**Conditional Use Permit — Casey's
Lot 3 Harrison Hills**

RECOMMENDATION REPORT

CASE NUMBER: PCUP 19-0004

RE: Conditional Use Permit – Initial Review
Proposed Casey's – 118th & Harrison
Lot 3, Harrison Hills
Convenience Store & Gas Station

AL-101

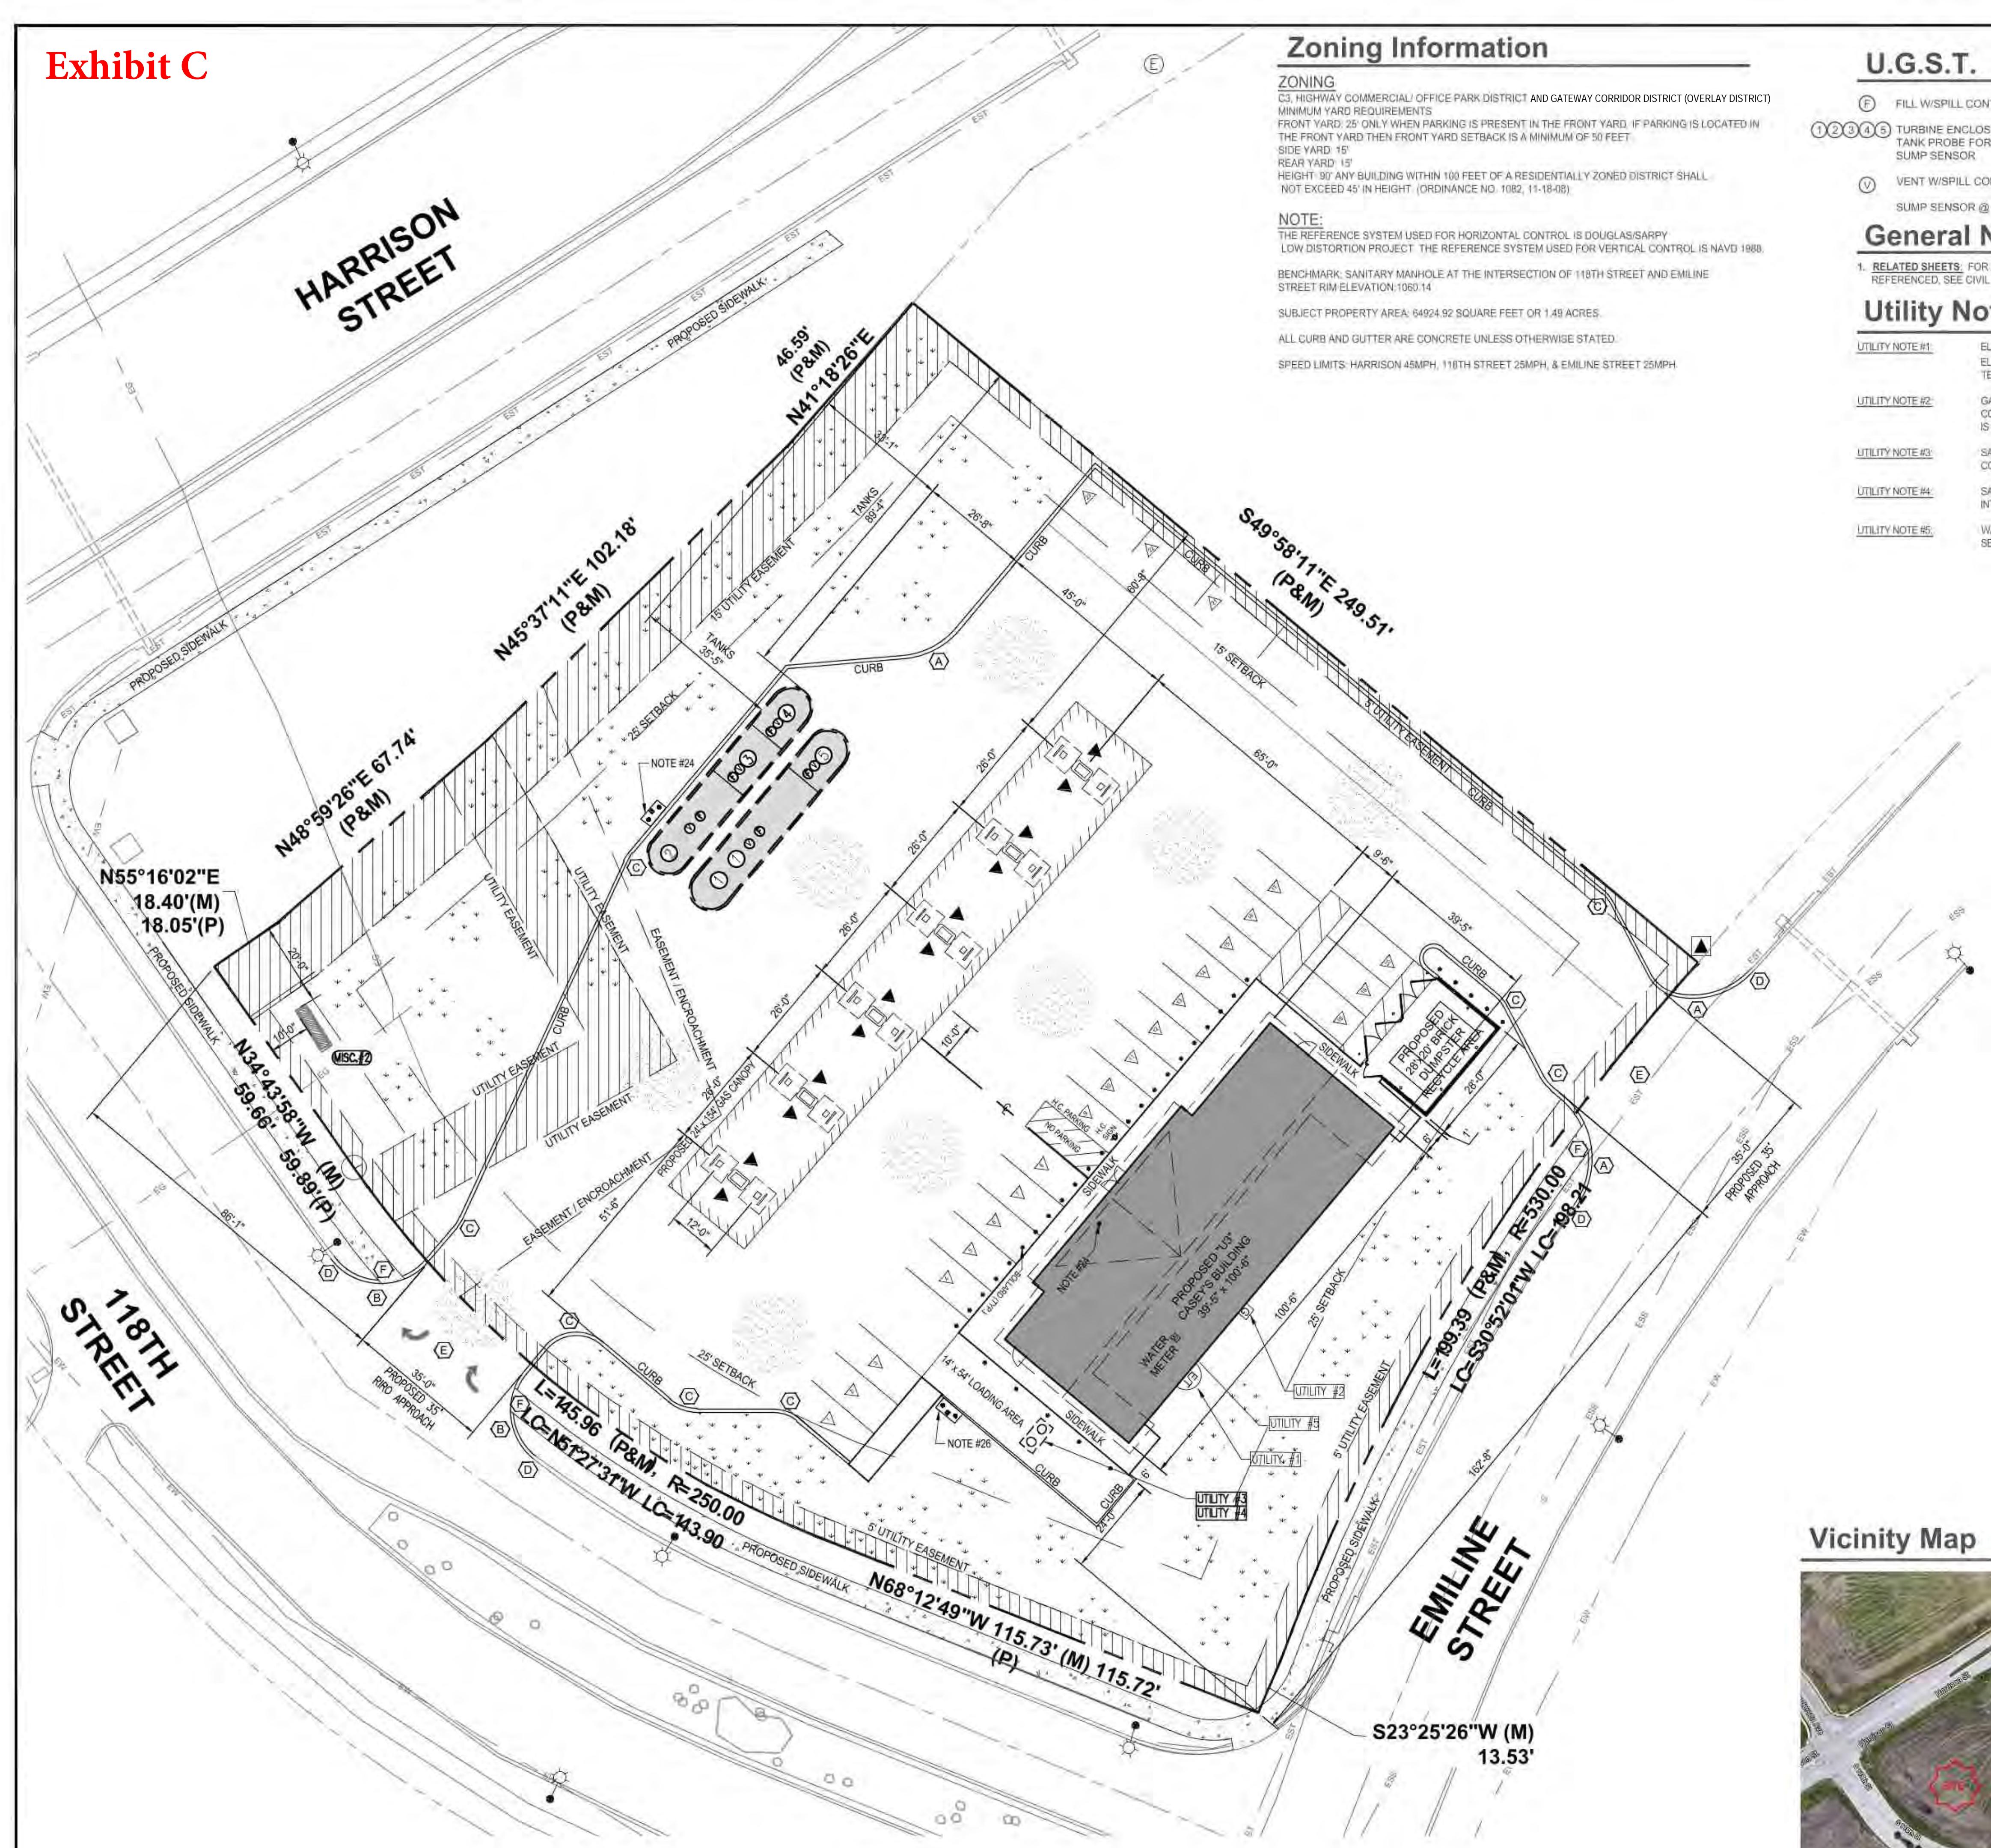
5. In regards to Article 6.05.09, site lighting will be reviewed as part of the design review process.
6. The zoning listed on the site plan needs to be revised to include "Gateway Corridor District (Overlay District)".

7. Strike "Misc. Notes" #1 as the dumpster design will be handled through the design review sheet set.
8. Strike "Misc. Notes" #2 as the signage will be handled outside of the Conditional Use Permit approval process.

9. Strike "Special Requirements" as most of the items listed will be handled within the design review exhibits to the Conditional Use Permit or through sign permits outside of the Conditional Use Permit approval process.

- a. We acknowledge that the site lighting will be review as part of the design review process.
- 6. The zoning listed on the site plan needs to be revised to include "Gateway Corridor District (Overlay District)".

- a. The zoning listed on the site plan has been revised to include "Gateway Corridor District (Overlay District).
- 7. Strike "Misc. Notes" #1 as the dumpster design will be handled through the design review sheet set.

- a. We removed this note from the site plan.
- 8. Strike "Misc. Notes" #2 as the signage will be handled outside of the Conditional Use Permit approval process.

- a. We removed this note from the site plan.
- 9. Strike "Special Requirements" as most of the items listed will be handled within the design review exhibits to the Conditional Use Permit or through sign permits outside of the Conditional Use Permit approval process.

- a. We removed this note from the site plan.
- 10. Project narrative mentions an "included sign packet". A "sign packet" was not included in the application submittal. Regardless, discussion about signage can also be removed from the Project Narrative as signage will be handled outside of the Conditional Use Permit approval process.
